2D drawing: 624693-01.2

Drawn 2014-04-22 Liridon Dana	Material		Mass
Reviewed 2014-04-22 Marcus Vardfjäll	For dim/radius < 0,5 without specified tolerance ± 0,05 applies		Status Released
Released 2014-04-22 Daniel Rådberg	Tolerance SS-ISO 2768 m/H	* = CRITICAL TO FUNCTION	Projection method E / ECM number 2405
Cochlear™	Name PROTOTYPE - Joe Dalton Pad Print		Scale 5:1 / Format A4 / Sheet 1/1 / Drawing number 624693 / Revision 01

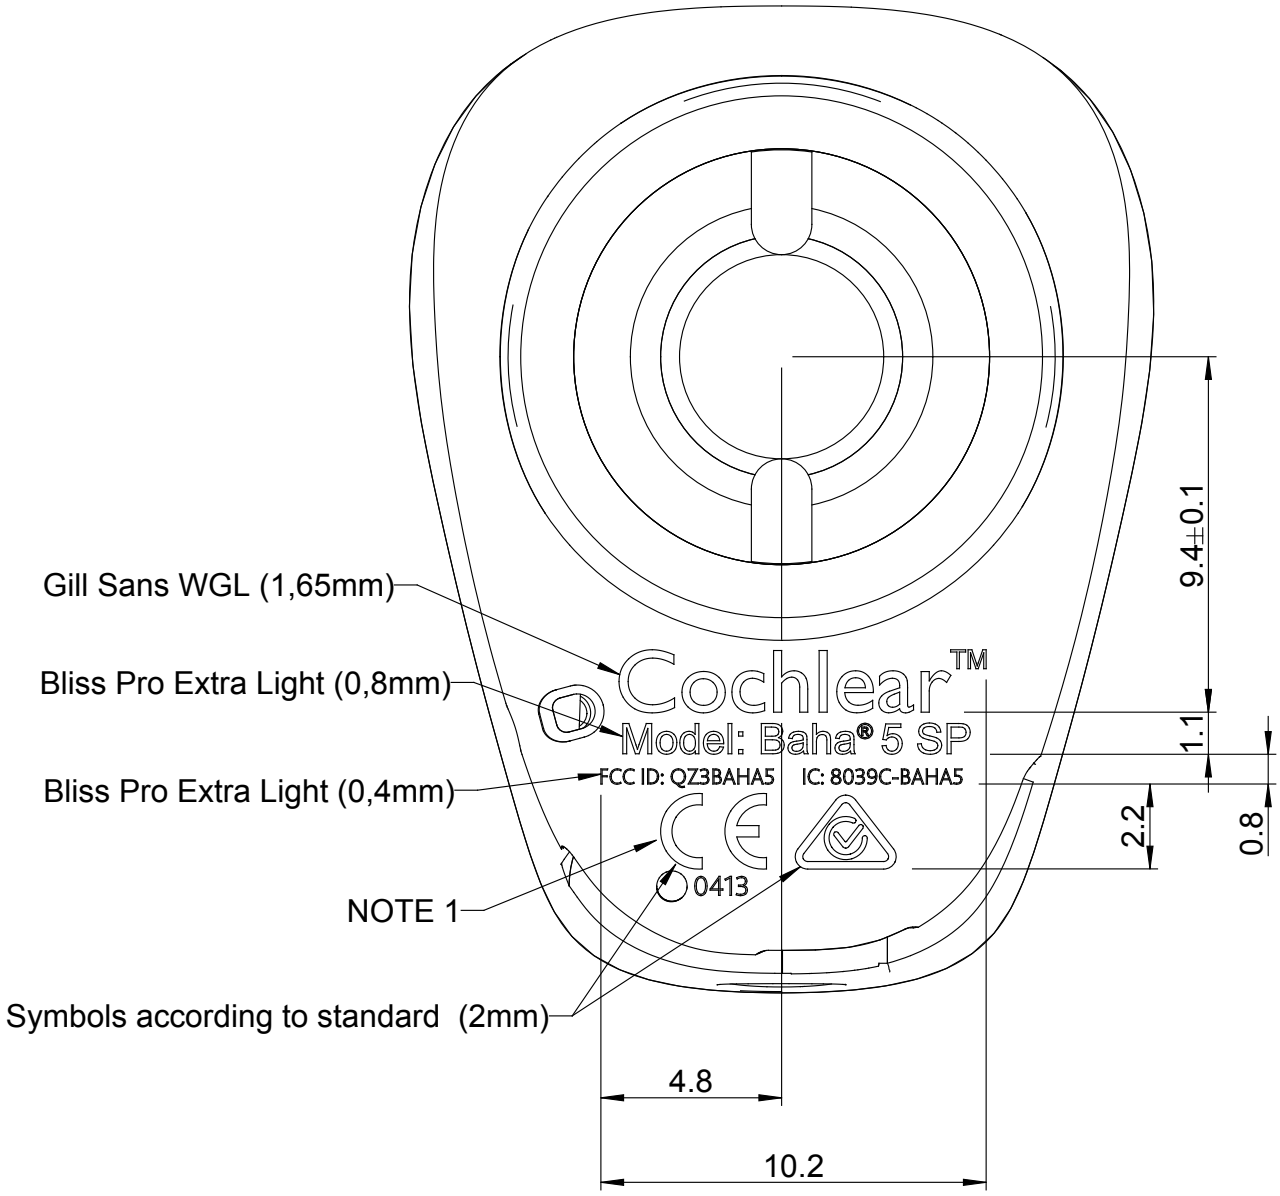
Revision	Zone	Nature of change A=Added D=Deleted W=Was
01		Tolerance was SS-ISO 2768 f/H
01	D6	Dimension 9.4±0.1 was 9.4
